**AGENDA FOR THE REGULAR MEETING OF THE
BRENTWOOD MUNICIPAL PLANNING COMMISSION
TUESDAY APRIL 7, 2020 -- 7:00 P.M.
BRENTWOOD CITY HALL**

**CITY OF BRENTWOOD
MUNICIPAL PLANNING COMMISSION
PLANNING DEPARTMENT STAFF REPORT
TUESDAY, APRIL 7, 2020 -- 7:00 P.M.
FINAL**

**Standard Illuminated
 Model Home Sign -
 Horizontal/Landscape Format**
 Entire logo is backlit

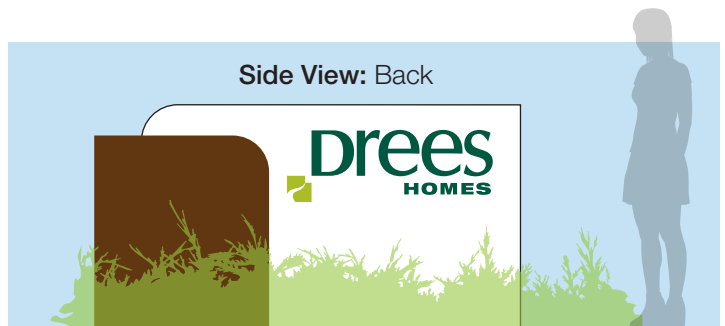
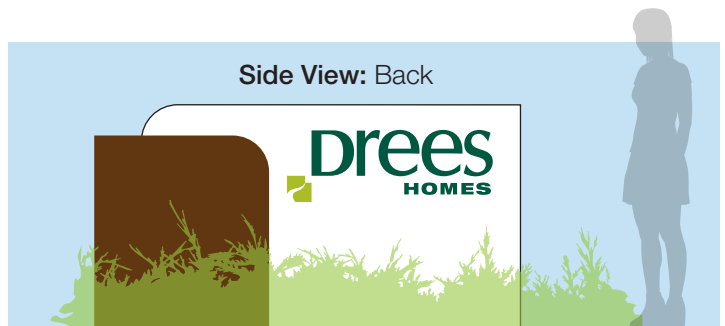
The proposed sign plan includes two options for the signage. One that is internally illuminated one that is not. Internally illuminated signs are prohibited by Code in residential districts.

1. Section 78-419 prohibits internally illuminated signs within residential districts. Revise the signage proposal as required.

Staff requests that the Planning Commission approve the proposed temporary model home for a period of 12 months until April 7, 2021, to include a sign that is not internally illuminated, subject to the requirements of the staff report.

NDM FLOORS DOCK RAMP
BRENTWOOD SOUTH I
VICINITY MAP

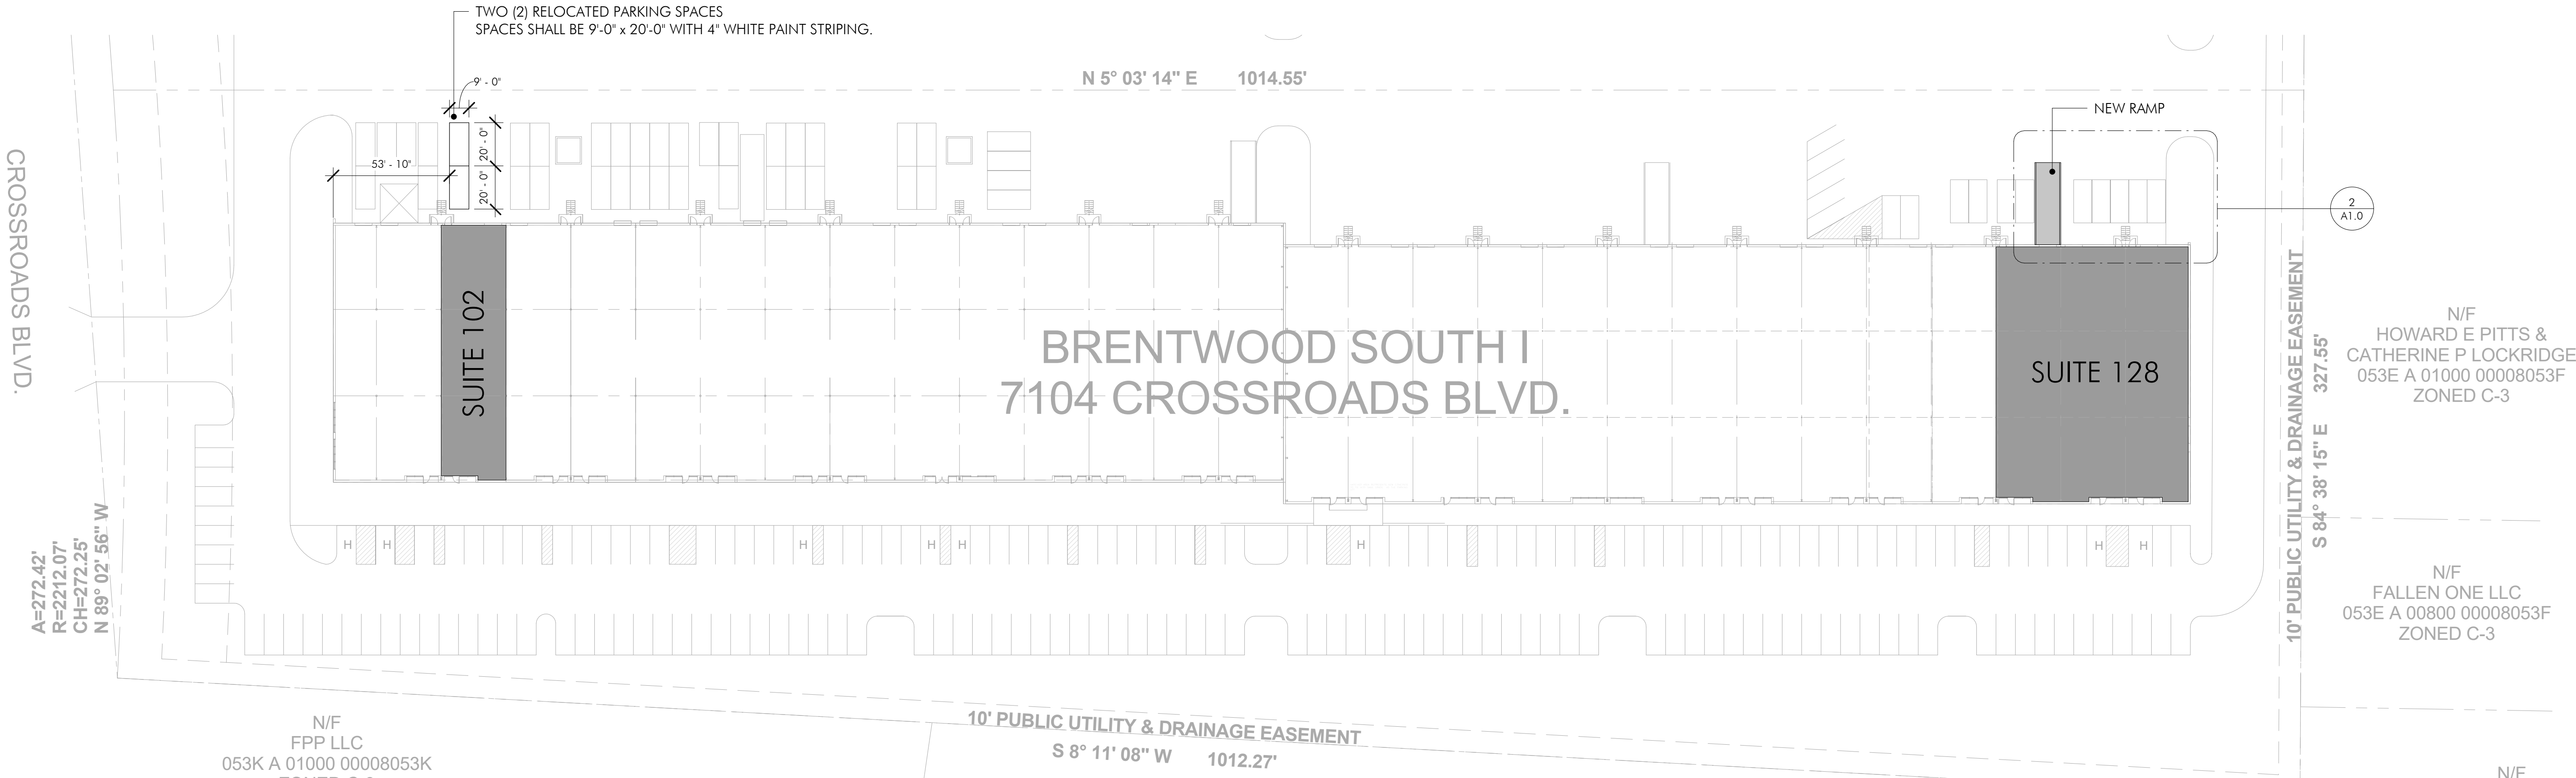
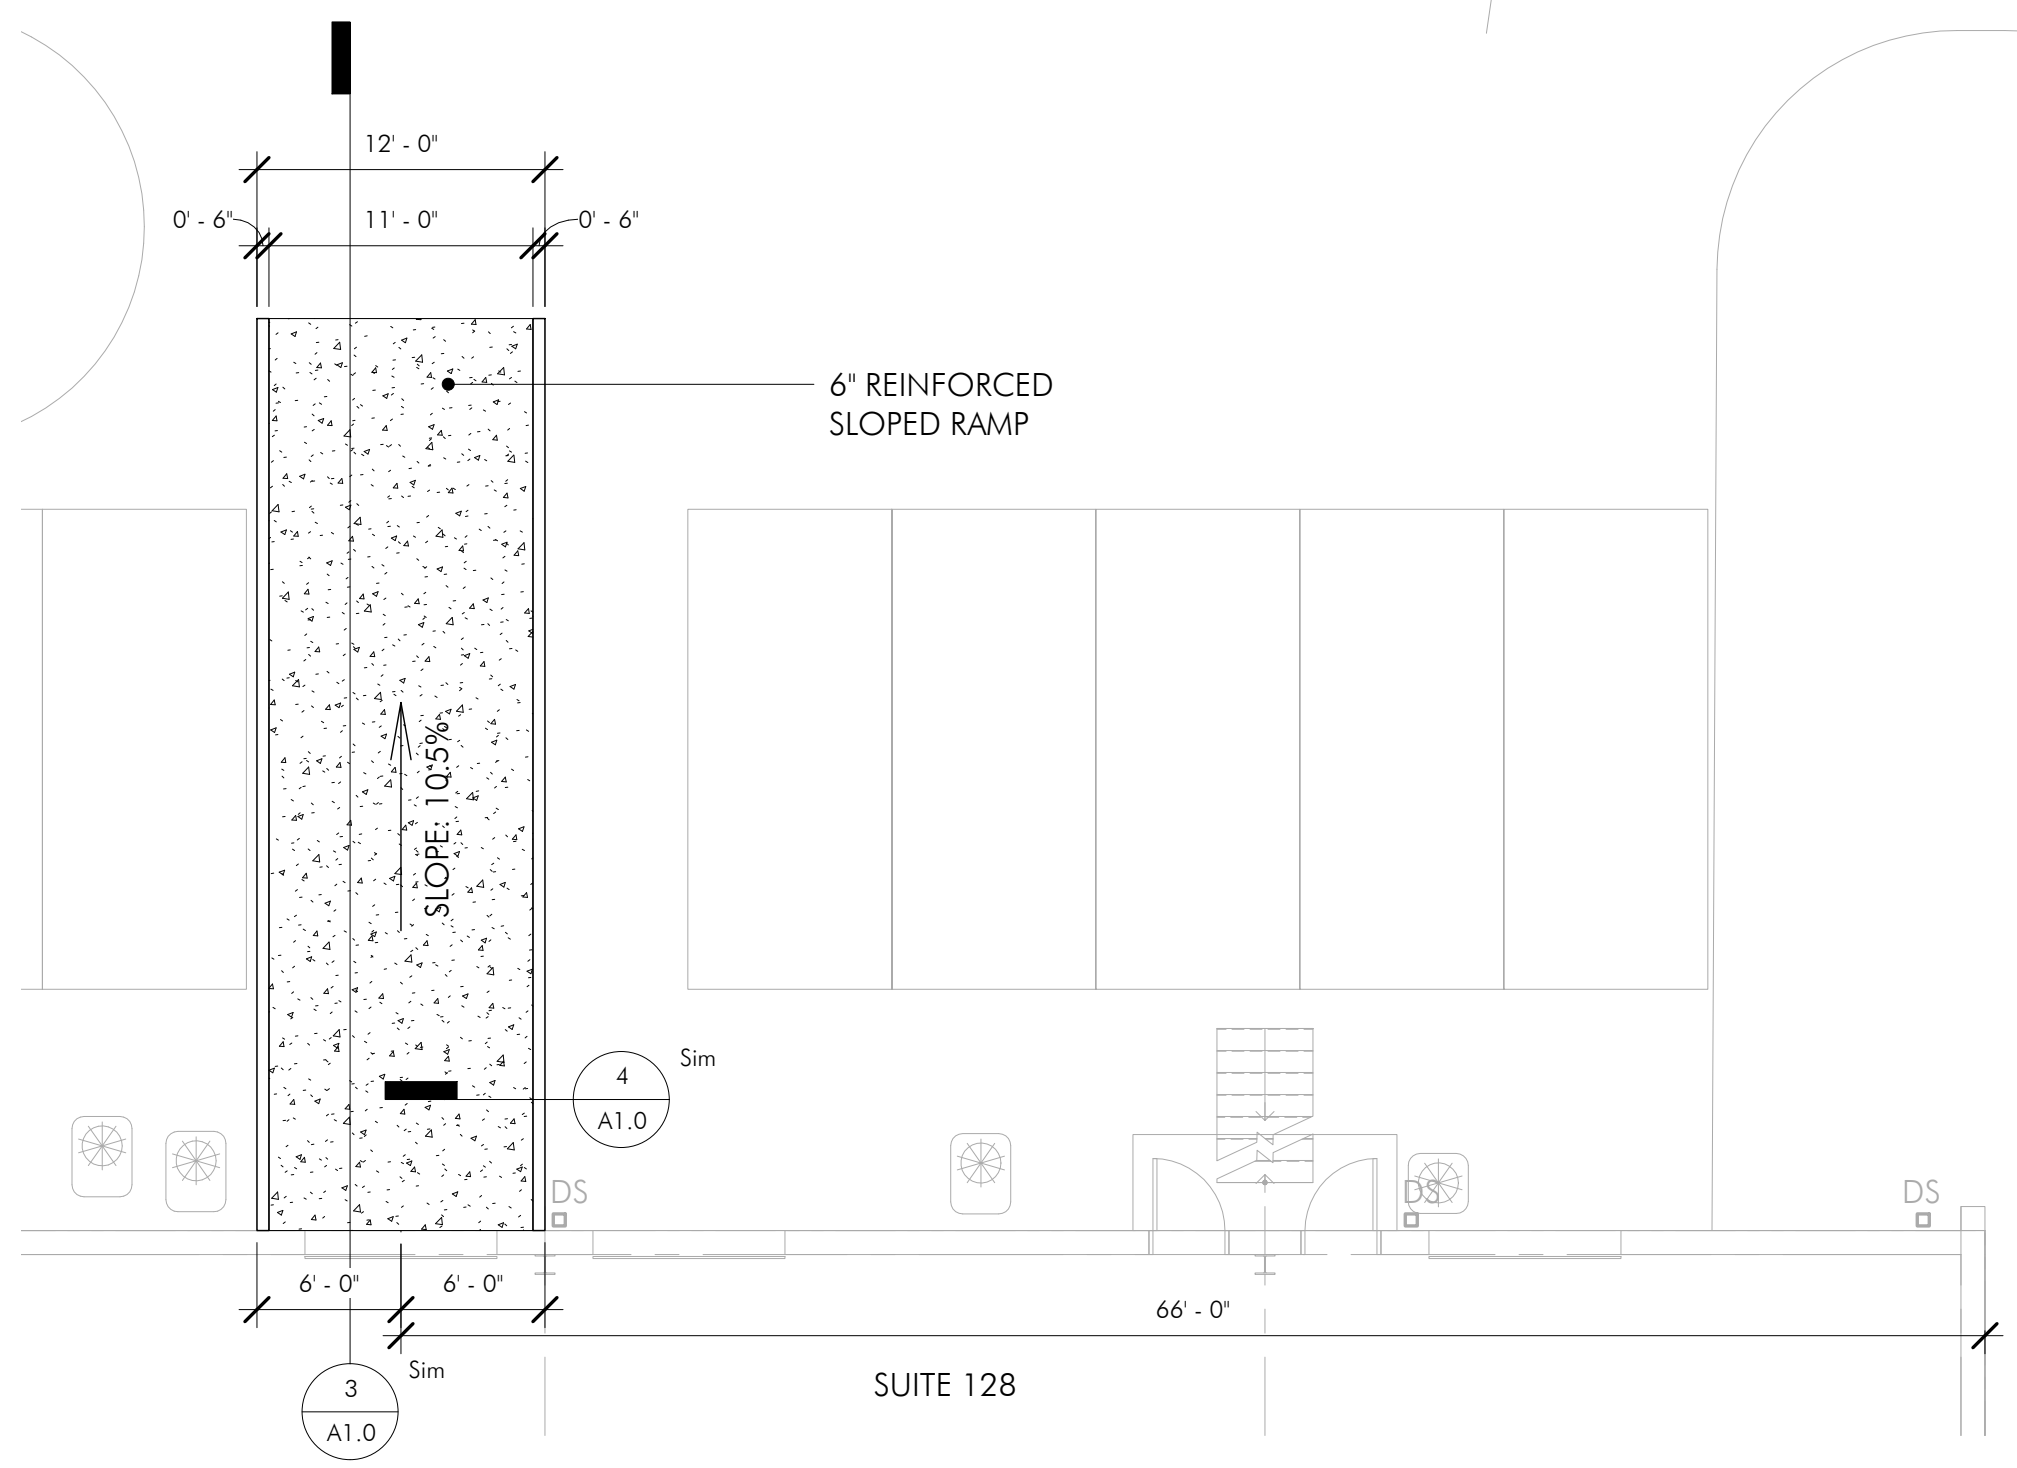
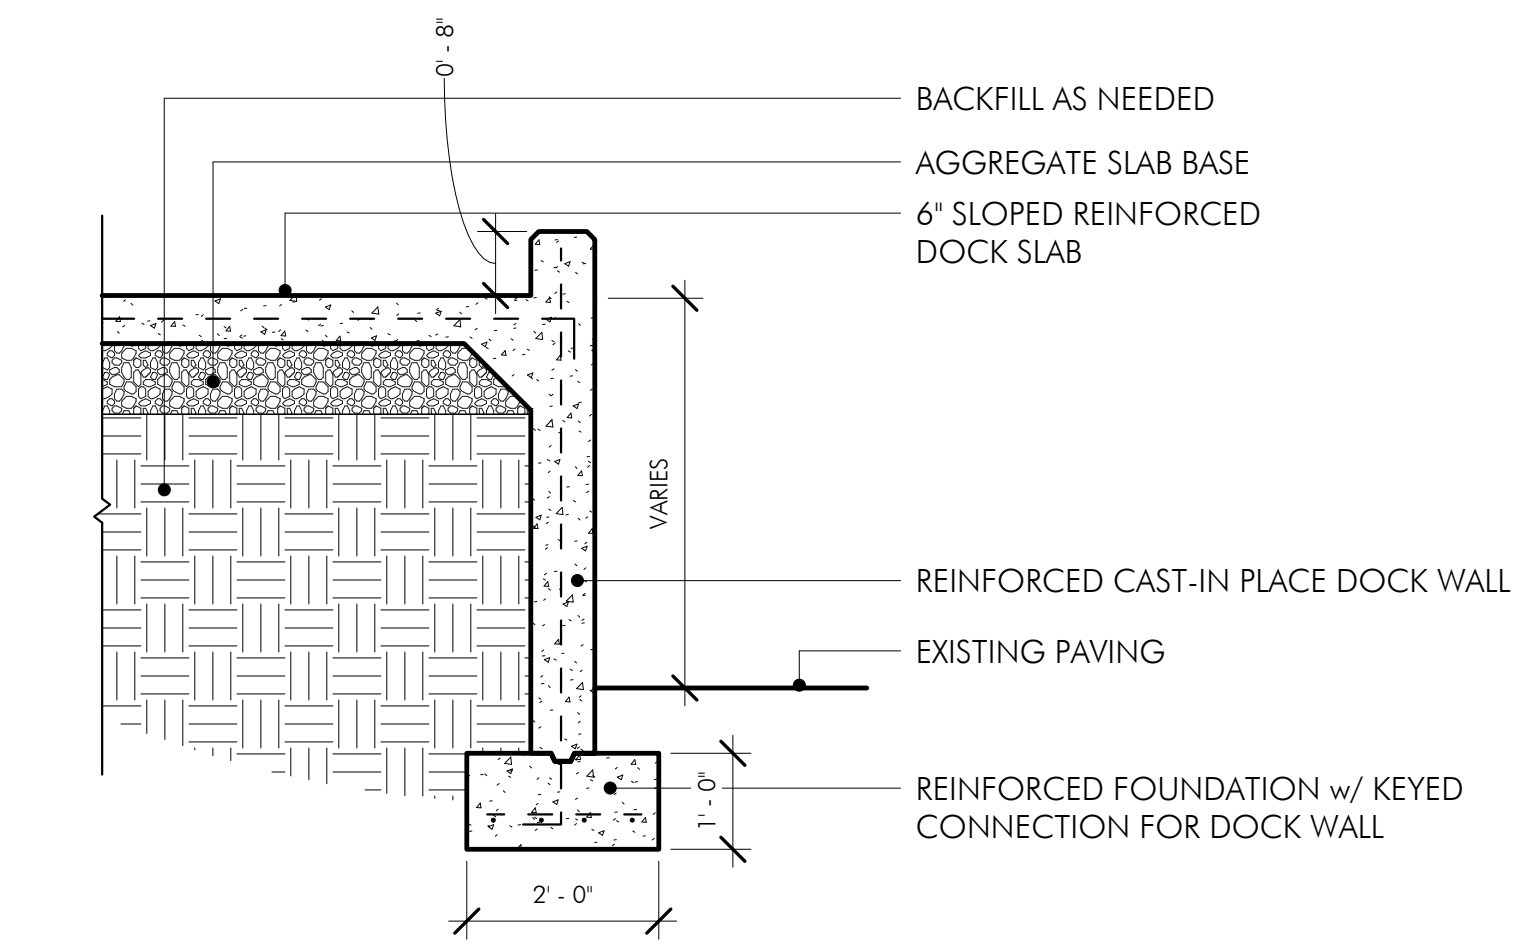
City Comment:
This site plan is subject to a three-year vesting period, during which the development standards in effect on the date of approval will remain the standards applicable to this plan. If construction is not completed during the first three years, the original site plan is considered a preliminary site plan and the applicant must obtain approval of a final site plan. Development of the property shown on this plan may be subject to standards other than those that were applicable during the vesting period. The initial vesting period for this plan expires on April 7, 2023, unless extended by the City of Brentwood. Persons relying on this plan after said date should contact the City of Brentwood to determine if development may continue as depicted on the plan.
